Project	IEEE 802.16 Broadband Wireless Access Working Group < <u>http://ieee802.org/16</u> >
Title	Periodic Ranging protocol update
Date Submitted	2006-09-26
Source(s)	Giulio CavalliVoice: +39 0224376380SiemensFax: +39 0224376726SS11 Padana Superiore km158mailto: giulio.cavalli@siemens.com20060 Cassina de Pecchi (Milano)Italy
Re:	Call for contribution
Abstract	Periodic ranging alignement
Purpose	update
Notice	This document has been prepared to assist IEEE 802.16. It is offered as a basis for discussion and is not binding on the contributing individual(s) or organization(s). The material in this document is subject to change in form and content after further study. The contributor(s) reserve(s) the right to add, amend or withdraw material contained herein.
Release	The contributor grants a free, irrevocable license to the IEEE to incorporate material contained in this contribution, and any modifications thereof, in the creation of an IEEE Standards publication; to copyright in the IEEE's name any IEEE Standards publication even though it may include portions of this contribution; and at the IEEE's sole discretion to permit others to reproduce in whole or in part the resulting IEEE St

Figure 82 – Periodic Ranging receiver process -BS

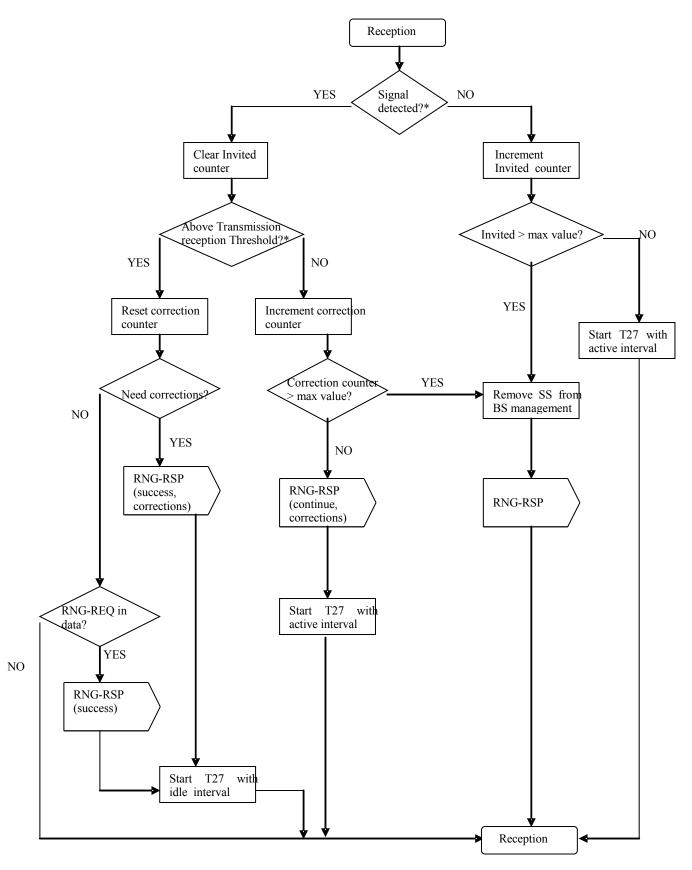
Replace figure 82 with the figure depicted below:
